FEATURE UPDATE

7800/9800 Series Graphic Keypads
March 2016

Version 108 Firmware Update

Micro SD
Card Slot

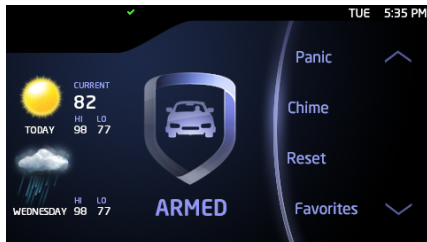
SD Card Firmware Update

Keypads with Version 107 software provide the ability to use the Micro SD card slot to load Version 108 or higher firmware updates without the need to return the keypad to DMP.

1. Navigate to dmp.com/dealer_direct and select Software Downloads. Select the 7800/9800 Software Update download. Enter your information to receive a download link for the .zip files.
2. After download is complete unzip the files and save the unzipped files to the root directory of a Micro SD card.
3. Insert the Micro SD card into the Micro SD card slot on the right side of the 7800/9800 Series keypad.
4. Enter the Installer Menu (3577), choose KPD OPT and press CMD to go to the Restart Keypad screen just after Select Language.
5. Press RESTART. The keypad will load the new firmware from the Micro SD Card and then restart.
   Caution: Do not remove the Micro SD card or disrupt power during this process.
6. When the keypad restart is complete, remove the Micro SD card from the keypad.

Carousel Navigation Arrows

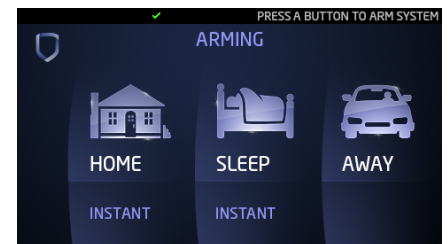
Navigation arrows now display on the top and bottom of the carousel on the main screen to allow page up and page down of the carousel menu. The ability to touch and drag the carousel menu up and down is still an available option.
